# UNITED STATES PATENT AND TRADEMARK OFFICE

10/562,166

Volker Krisch

<b>Office Action Summary</b>	<b>Application No.</b> 10/562,166	<b>Applicant(s)</b> KRISCH ET AL.	
	<b>Examiner</b> ALYSON M. MERLINO	<b>Art Unit</b> 3673

**FIG. 4**

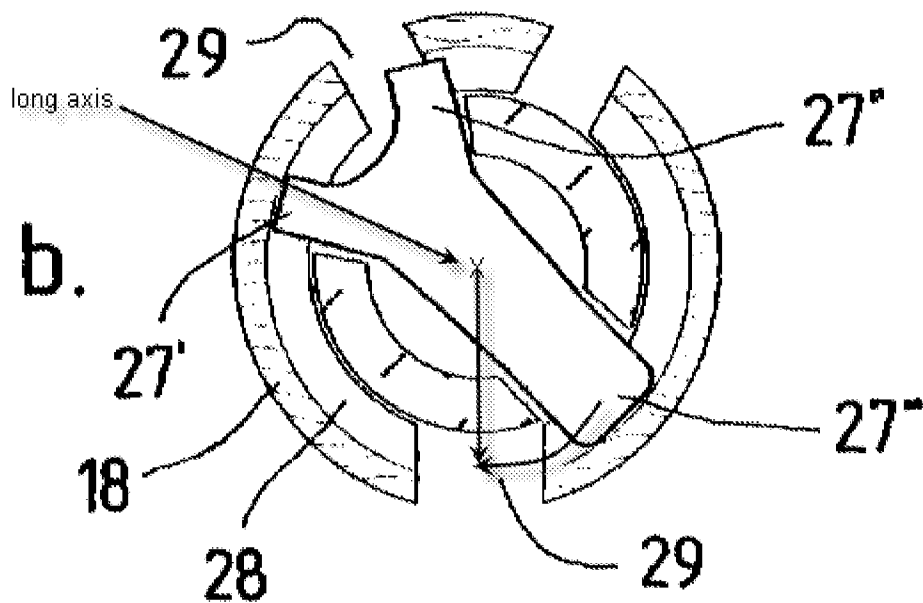
5. **In regards to claims 19, 36, 37, and 53**, Niemann discloses an electromechanical lock cylinder (Figure 1) that cooperates with evaluation electronics to recognize access authorization, comprising two opposite cylindrical receptacles 12, 13, at least one of which includes a lock core 14, which can be operated by a key (apparent from Figure 1) that is mounted to rotate, in which the lock core cooperates with the lock tab 17, 18, which operates, in particular, a bolt or latch of a door lock (Paragraph 26), and with a fitting key (Paragraph 25), an electromechanically driven blocking or coupling element (Figure 4b) is moved from a rest position (Figure 2) to an operating position and produces a splined connection between the key and the lock tab (Figure 5b), whereas the lock tab, in the rest position of the blocking or coupling element, is freely rotatable (apparent that there is no connection in Figure 2) relative to the lock core, wherein the blocking or coupling element is arranged on the lock (apparent from Figure

1) and rotates with it (apparent from Figures 2 and 5, rotates when coupled together), and includes an eccentric 26 that is rotatable between a first (Figure 4b) and second (Figure 5b) position such that when the eccentric is in the first position, a driver 27" in communication therewith is in a rest position (apparent from Figure 4b), and when the eccentric is rotated from the first position to the second position, the driver is moved in a direction substantially perpendicular to a long axis (see figure below) of the lock core into an operating position (see figure below) in which the driver engages in a recess 29 of the lock tab.

The claim only recites an "eccentric," which leaves the claim language open to a number of interpretations. For example, it is clear that the center of mass of the eccentric 26 is off center or eccentrically located from its axis of rotation, see the annotated figure above, therefore, the eccentric 26 has an axis away from the center. Also, the coupling element 26 of Niemann is considered an eccentric since it is unusual in shape. Applicant merely alleges that component 26 is not an eccentric, however, applicant has not set forth the definition of an eccentric that applicant is considering, and the claim language does not provide any further structure to the eccentric. It is clear from the annotated figure on Page 5 that the eccentric 26 of Niemann has a driver 27" that moves in a direction "substantially perpendicular" to a long axis, shown in the annotated figure, of the knob shaft or lock core as claimed, with this direction of movement indicated by the arrow near the indicator of reference character 29, which is clear from the movement from Figure 4 indicating the rest position to the position in Figure 5 showing the operating position, in which the driver engages in a recess 29 of the lock tab, see Figure 5, as claimed; therefore, the rejections are maintained.
